Urban Design Committee Agenda

**AGENDA
February 6, 2008**

TO: Urban Design Committee
FROM: Brian Will/ Planning Department
DATE: February 1, 2008
RE: Alltel proposal for a wireless facility at Seacrest Park

**70th & A
 CANDIDATE #1**

1 EAST ELEVATION

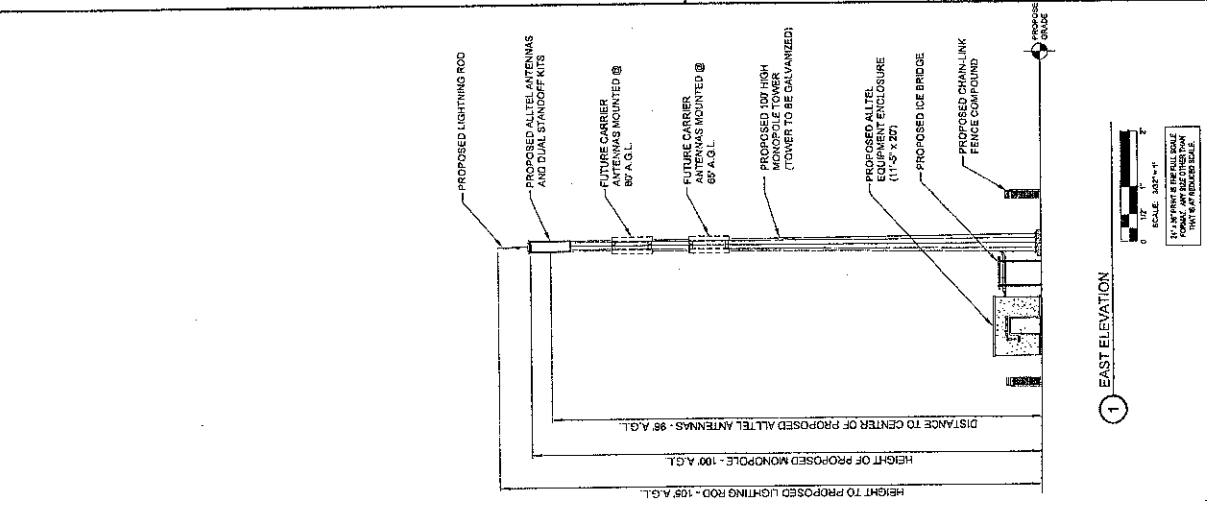
A neutral (gray) galvanized monopole is proposed.

The plans submitted show the tower is structurally capable of accommodating two additional carriers.

SHEET NUMBER
L-1

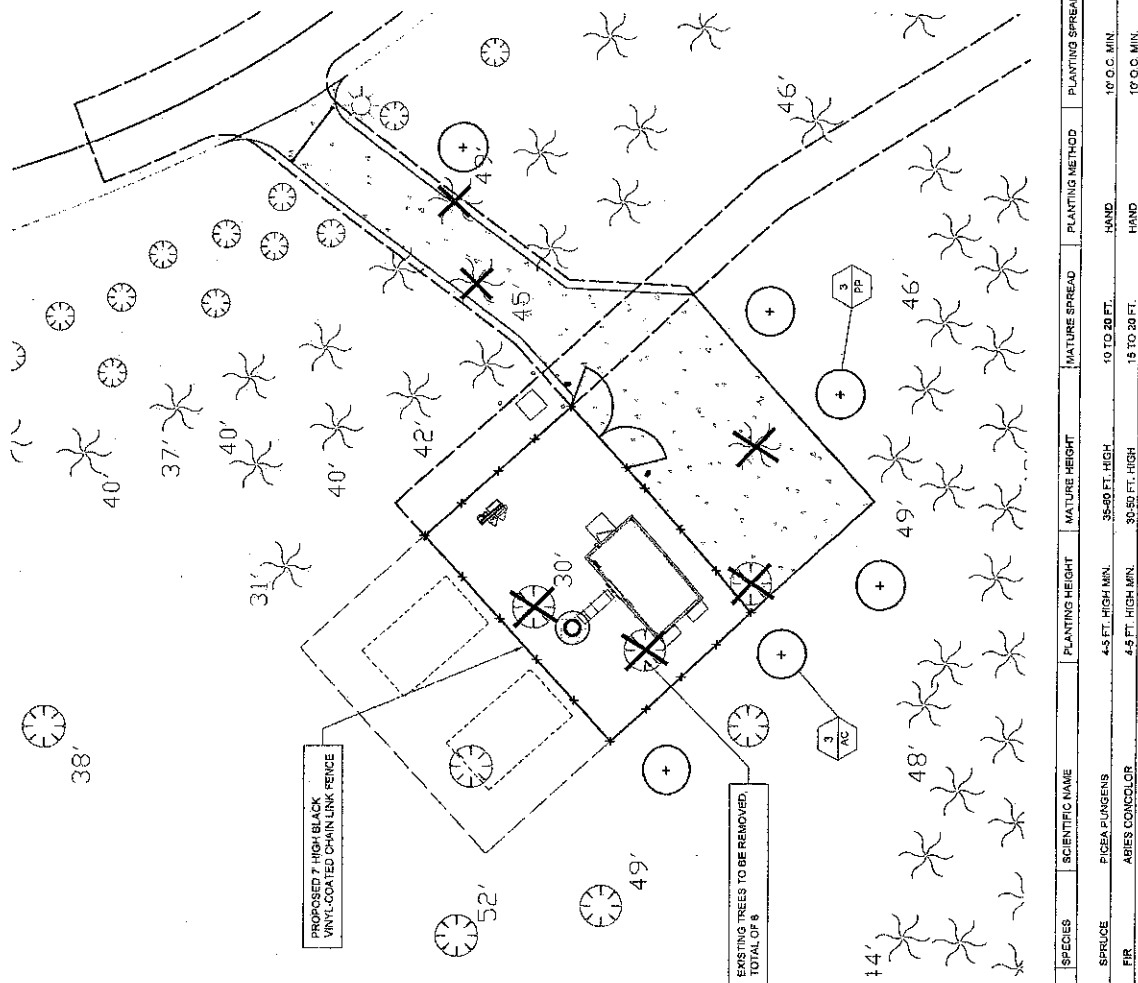
There is an existing stand of mature pine trees surrounding the proposed site. The site plan shows additional trees being planted near the base of the tower to further screen the facility from A Street and the properties south of the site.

Lincoln - 70th & A
After - View Looking South

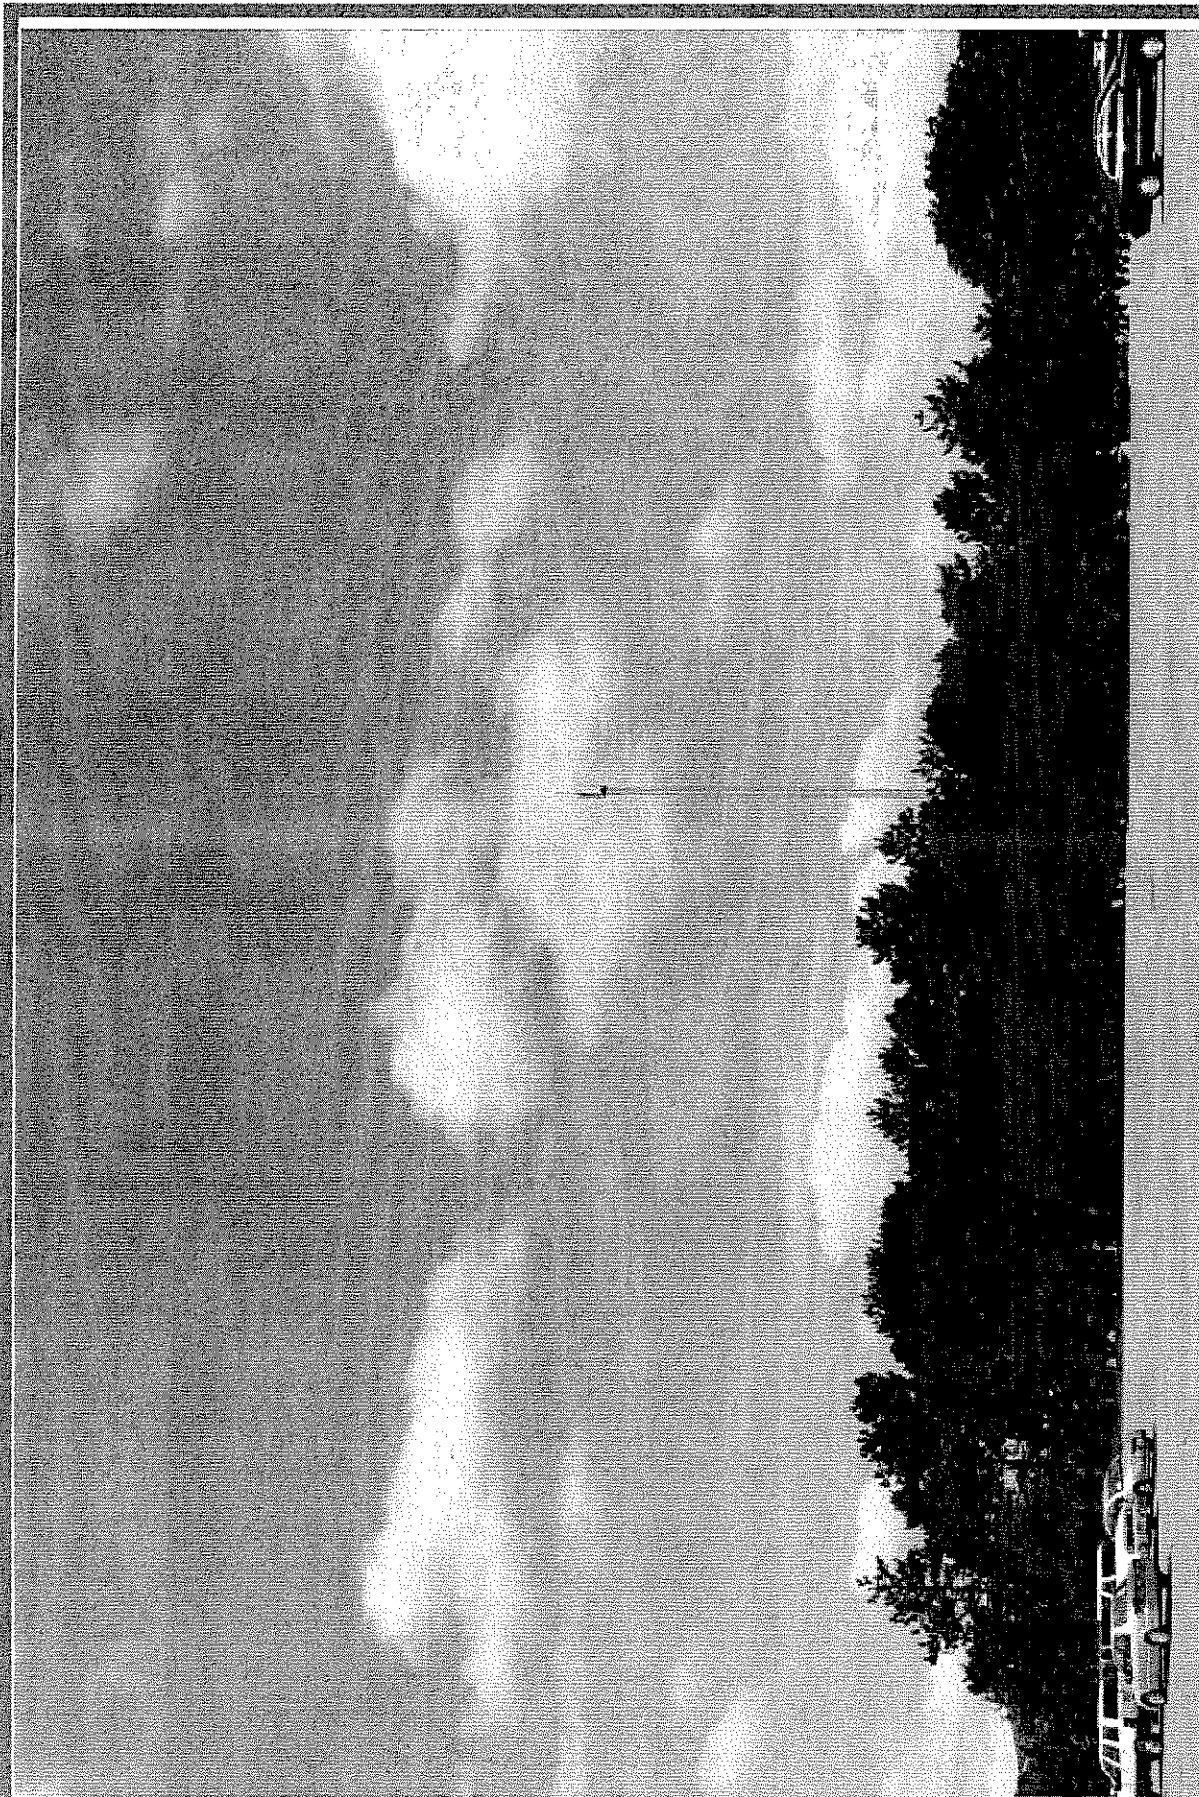
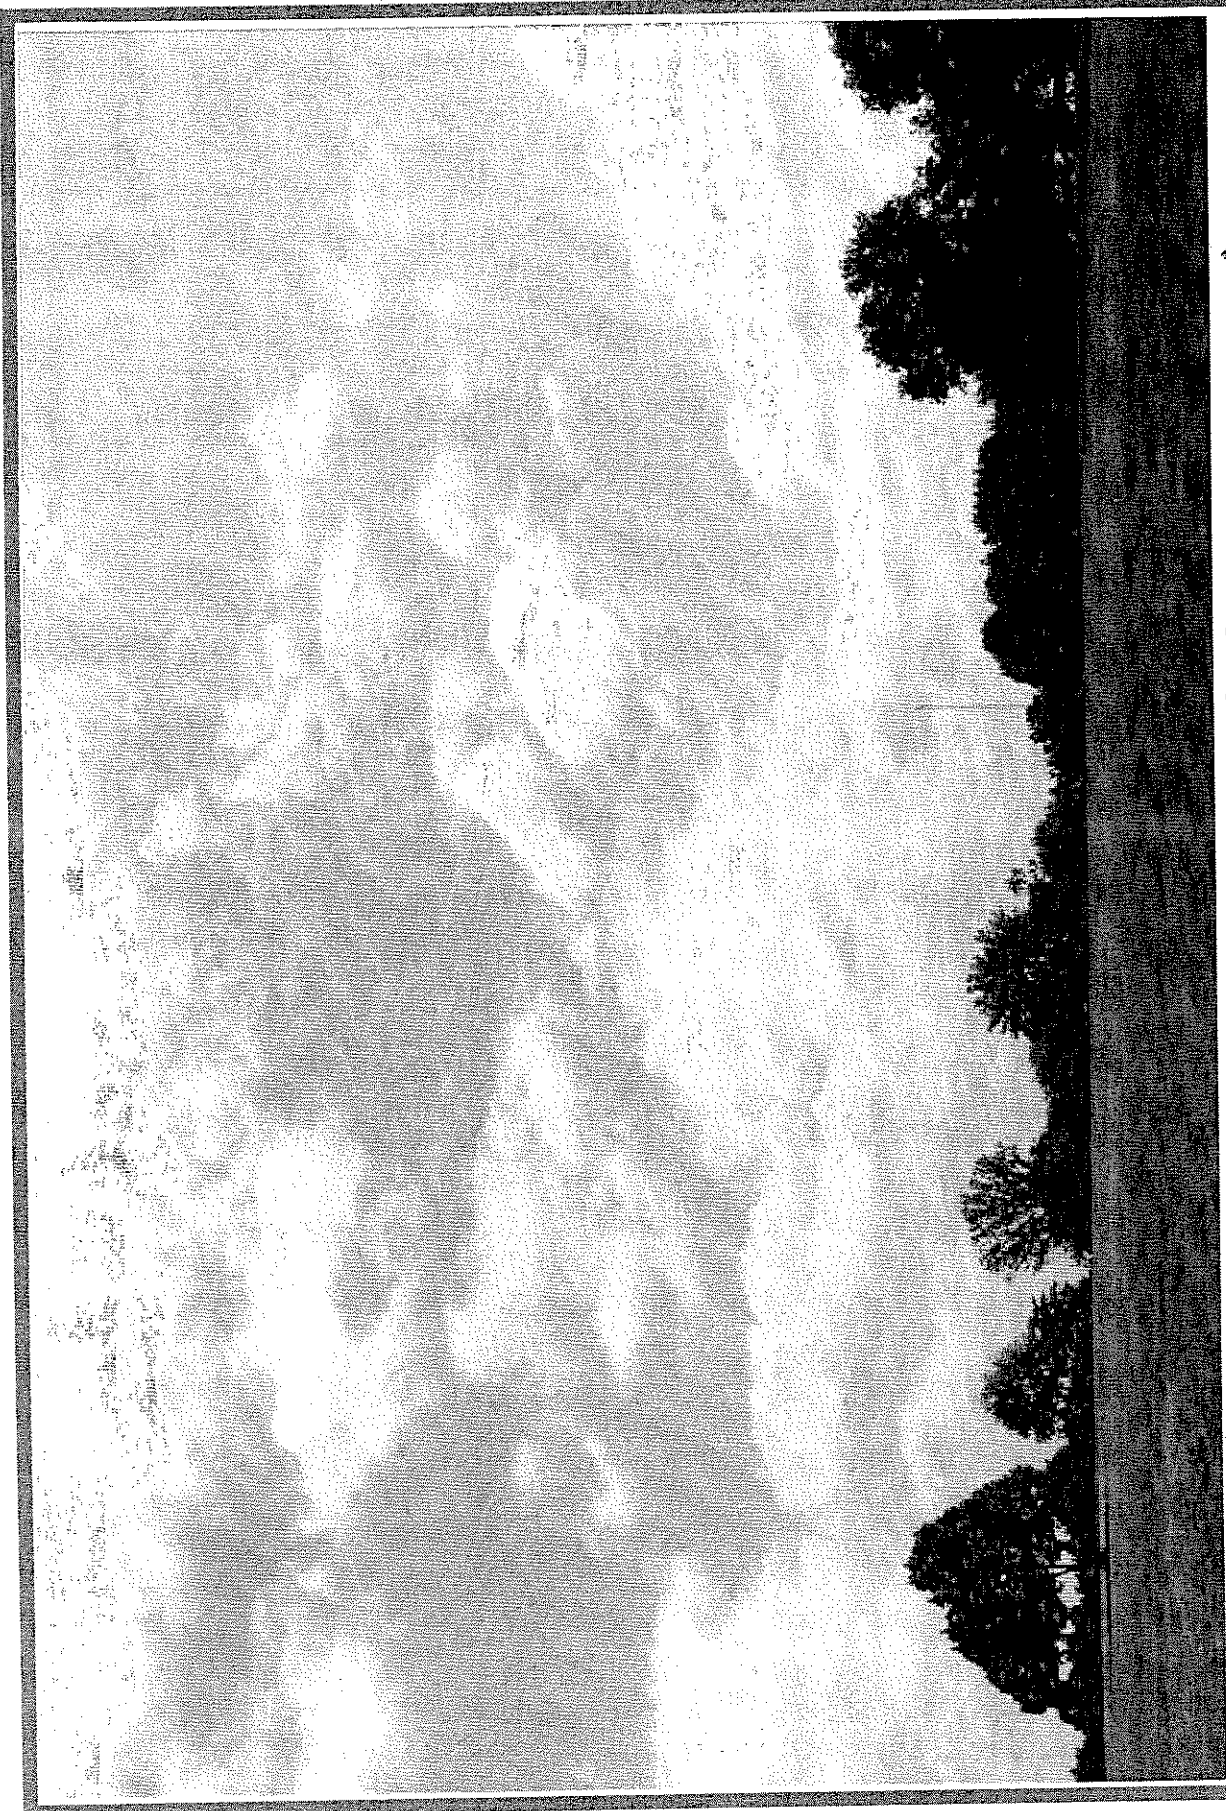
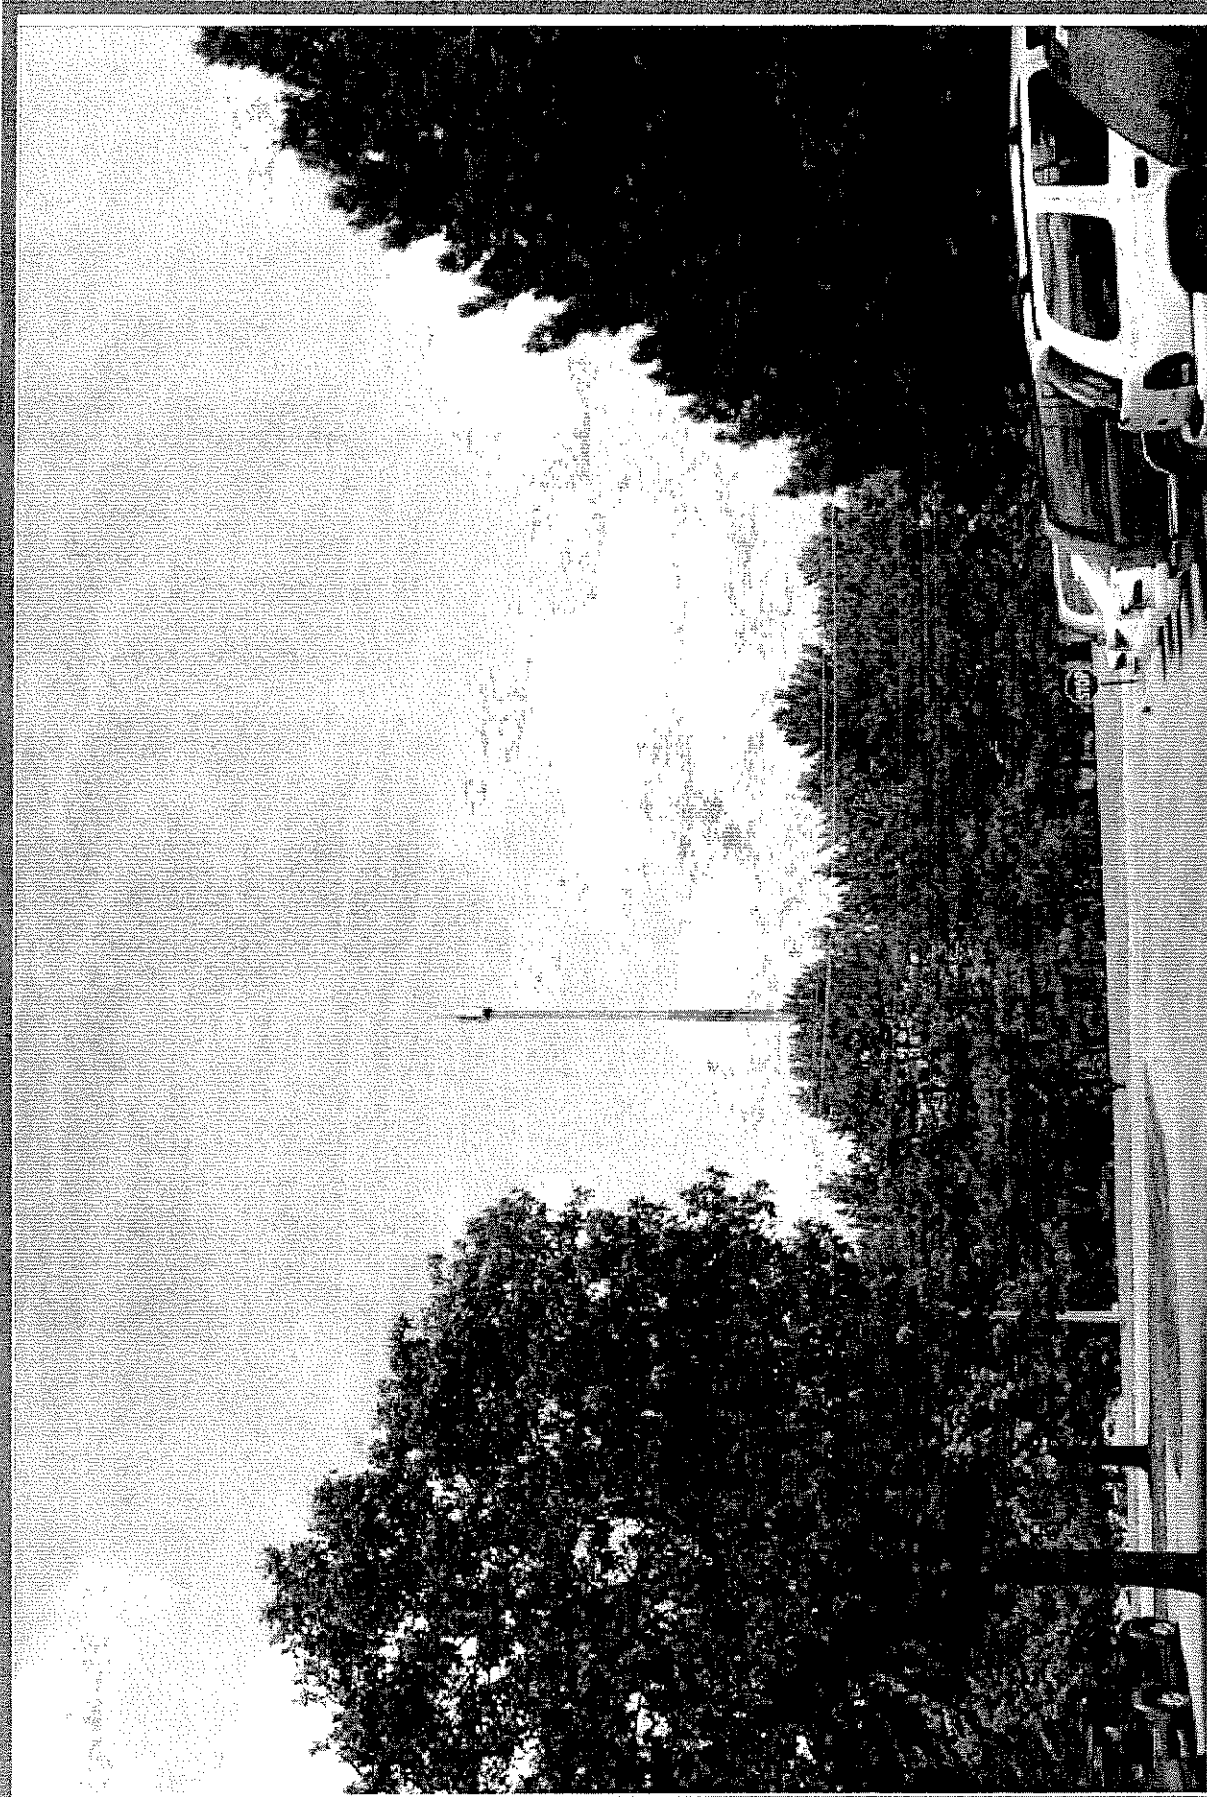
The proposed tower does not appear to have a negative impact on views/vistas of the Capitol, landmark structures or districts.

The proposed tower will be visible from the East High School, Seacrest Park, and A Street.
